INNER WEST

DEVELOPMENT ASSESSMENT REPORT

Application No.	MOD/2020/0073
Address	147 New Canterbury Road LEWISHAM NSW 2049
Proposal	Section 4.55 (2) Modification to DA201700003.01 involving internal and external modifications to the approved mixed use development including proposed reconstruction of the first floor portion of the existing front façade wall facing New Canterbury Road.
Date of Lodgement	17 March 2020
Applicant	Benson McCormack Architects
Owner	Peter Gabriel Pty Limited, Steve Gabriel Pty Limited, Kon Gabriel Pty Limited, Aziz Gabriel Pty Limited
Number of Submissions	Initial: 0
Value of works	\$12,663,699.00
Reason for determination at Planning Panel	Further variation to maximum building height exceeding 10%
Main Issues	Height of development
Recommendation	Approval with Conditions
Attachment A	Recommended modified conditions of consent
Attachment B	Plans of proposed development
Attachment C	Consent Modified Determination No. 201700003

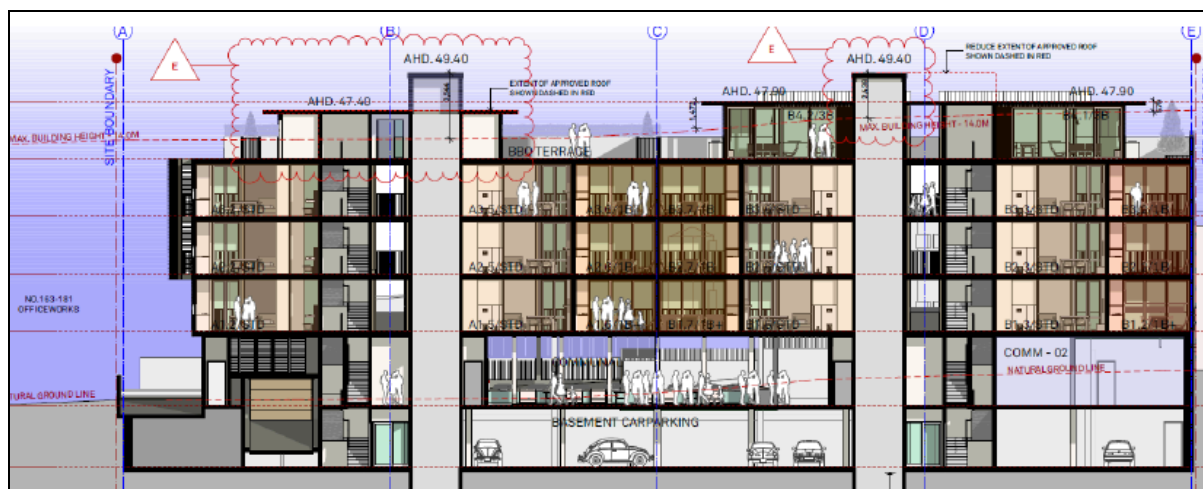
The subject development seeks to extend the lift of Building A all the way to the rooftop level, and reconfigure the roof to contain a lift lobby area. The extension of the lift creates additional height needed to accommodate the lift overrun, and therefore has a maximum height of AHD 44.80, matching that of Building B. This is demonstrated in the figure below:

The development therefore seeks a maximum height of 17.42 metres, resulting in a variation to the maximum height of buildings development standard of 3.42 metres or 24.4%. The development seeks a further increase in height of 984mm or 7%.

It is noted that the other proposed alterations to the lift lobby area including the relocation of the bathroom, hot water pump room, air conditioning condenser units and plant room also breach the height standard, however to a lesser extent than the lift overrun.

“As the above [figure] shows, the natural ground line slopes down to the west. Despite matching the same RL, the lift overrun for Building A is technically a greater overall height due to the existing natural slope.
